C. Reiss Coal Dock., BRRTS # 02-16-589248 Monitoring Well MW20

MW20 – Monitoring well 20, C. Reiss Dock Property, Superior, WI BRRTS # 02-16-589248

Subject: RE: C.Reiss Update

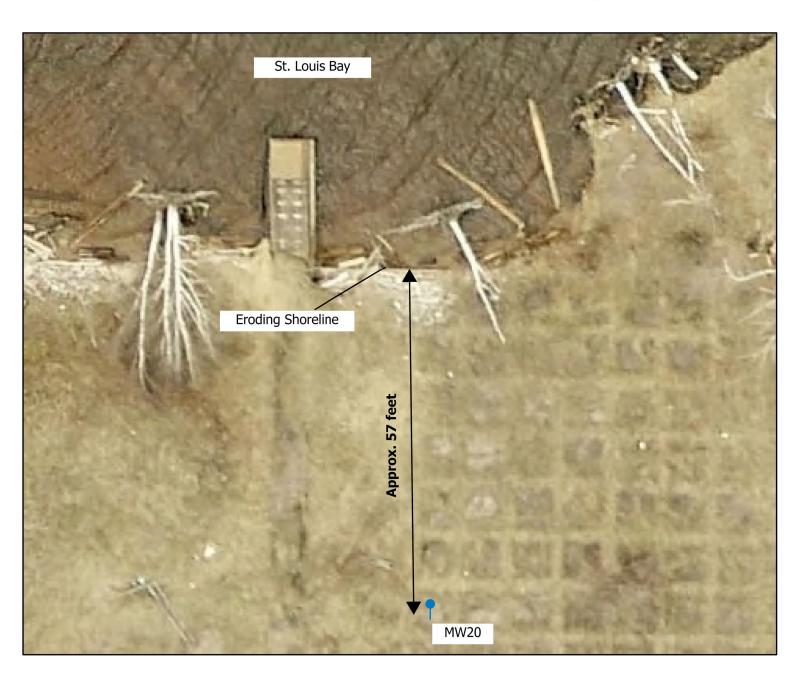
Attached is the comparison of the arsenic results from MW-20 to the applicable standards of in NR 140 and NR 105 and comparisons to the levels at the Superior wastewater plant.
